### ADDENDUM 1

CSP 22-92

## Cavazos Elementary School Heating & Air Condition (HVAC) Improvements Funded through the Elementary & Secondary Emergency Relief (ESSER) Funds May 31, 2022

## Addendum

**LEVEL 1 ELECTRICAL POWER PLAN - AREA D**

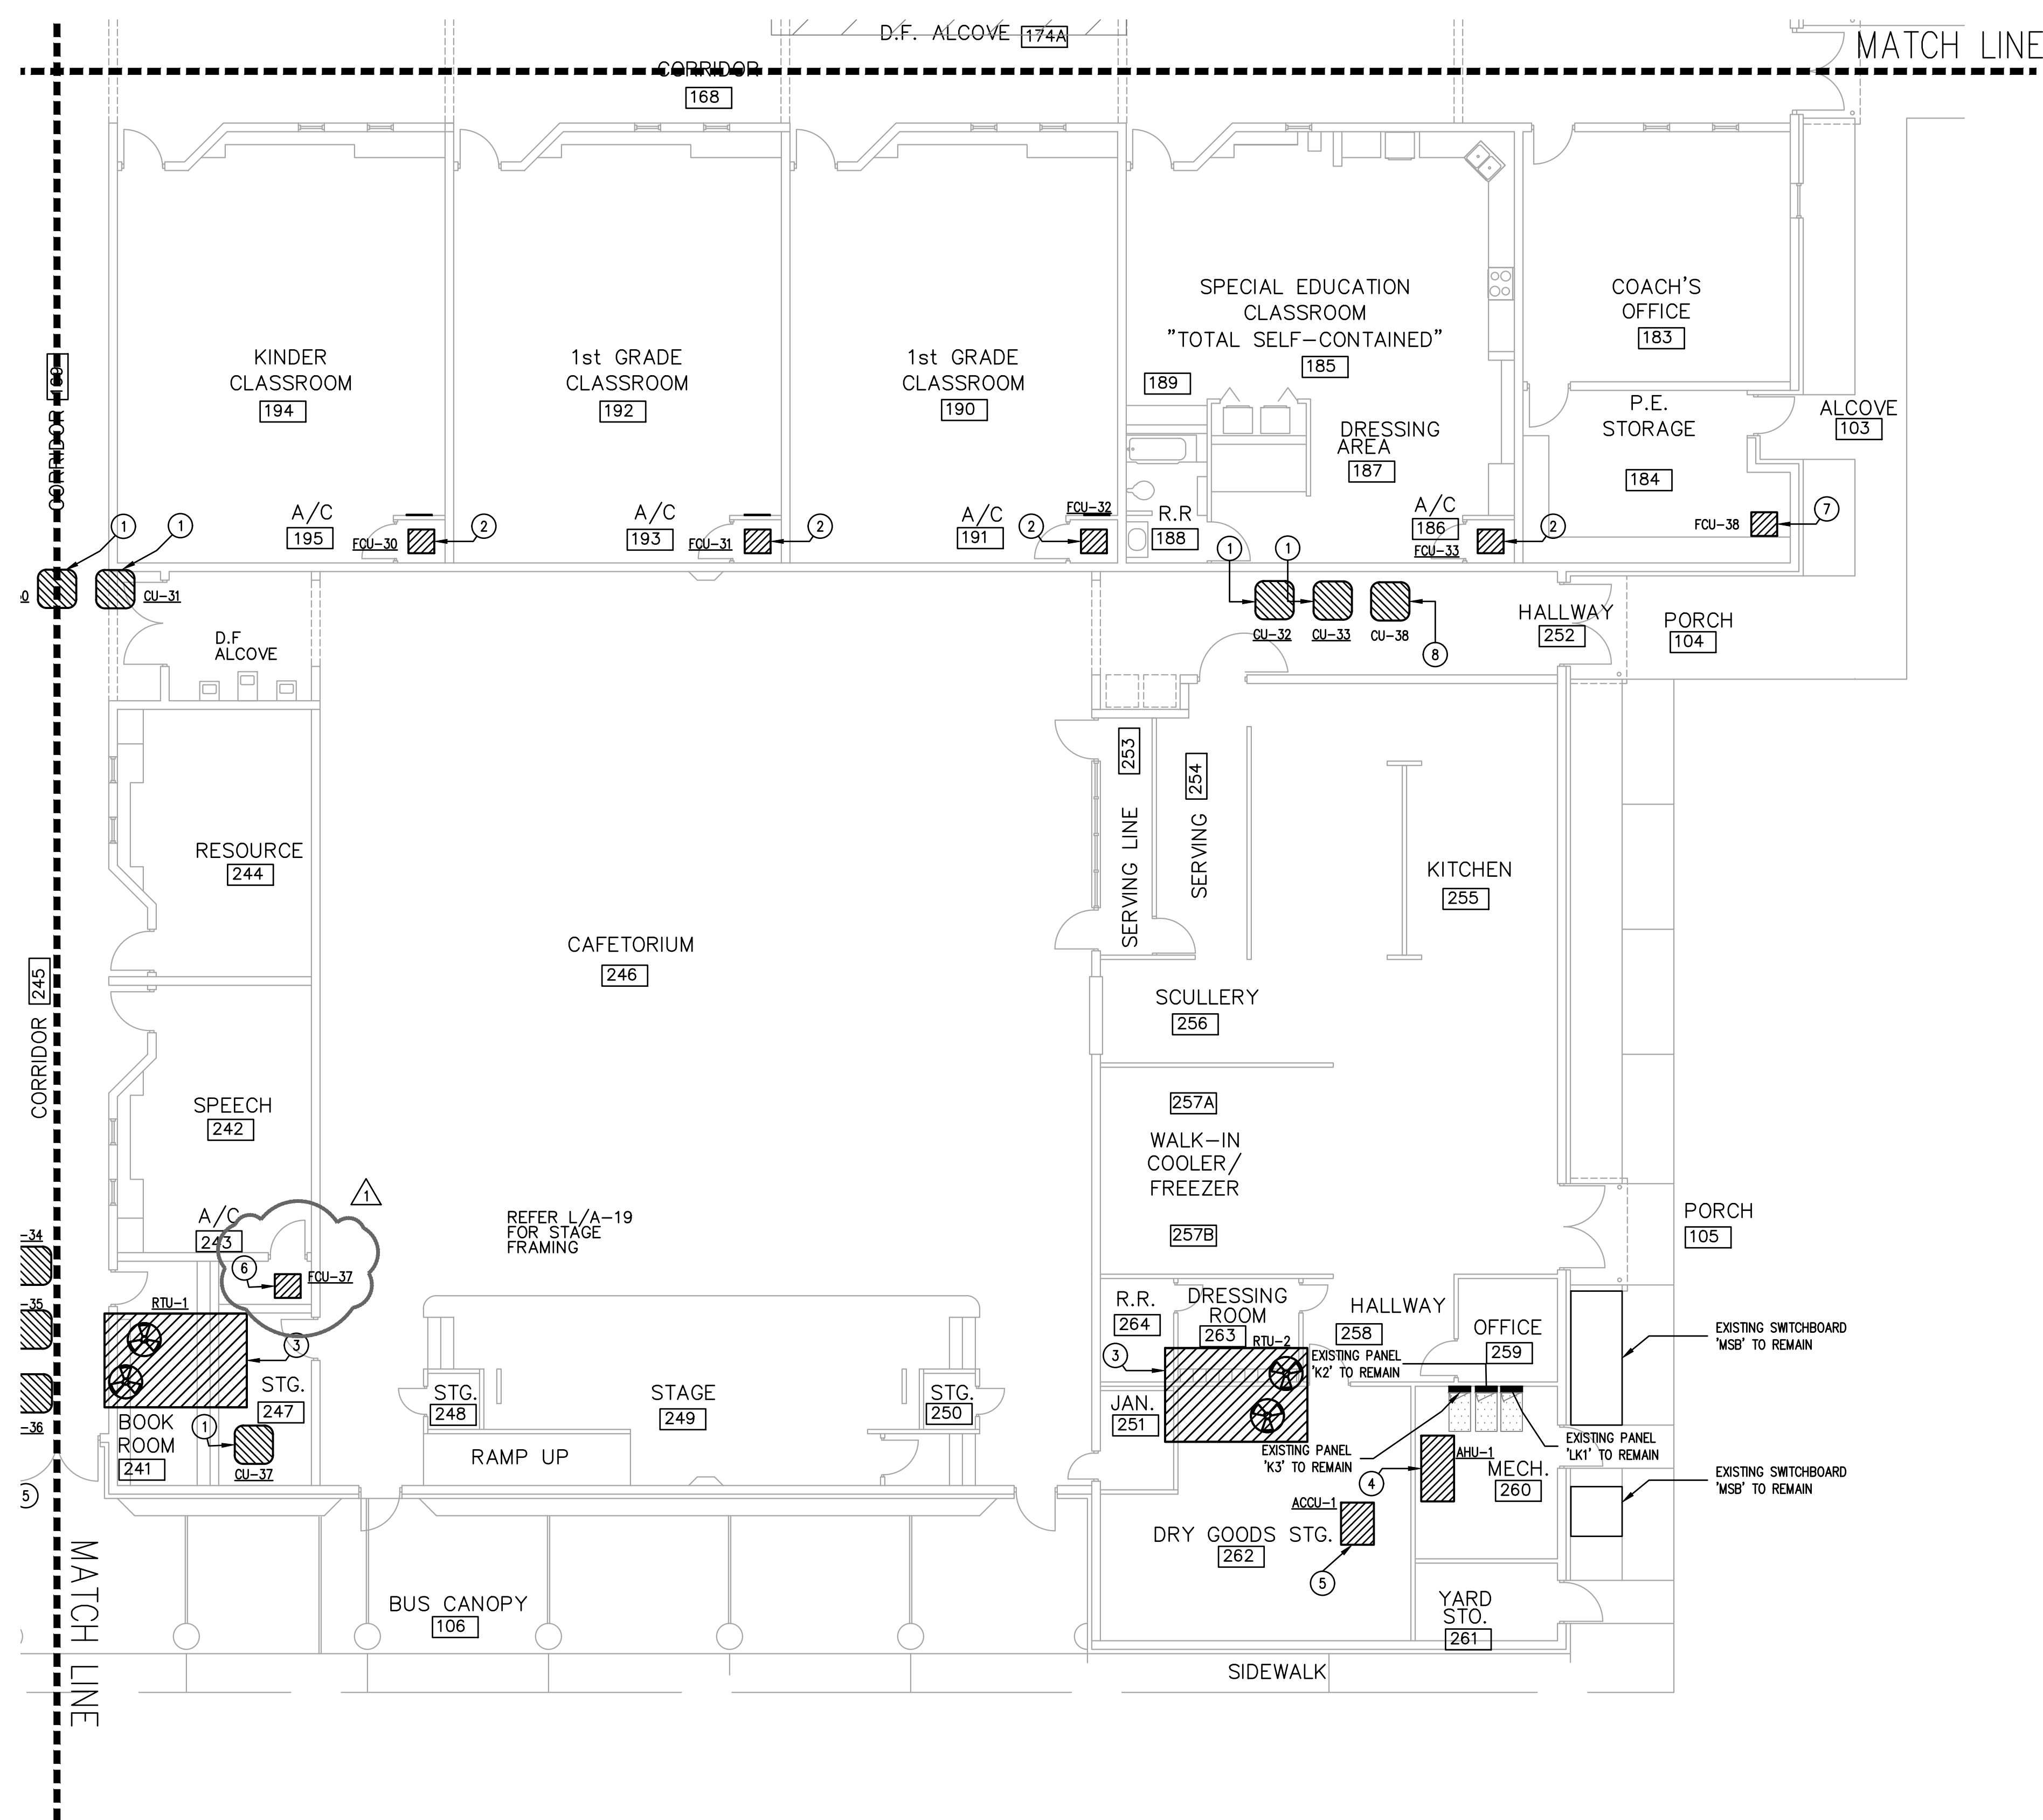
**Item 19**            **EP2.14D – LEVEL 1 ELECTRICAL POWER PLAN – AREA D**

- A.     Revised keyed notes.
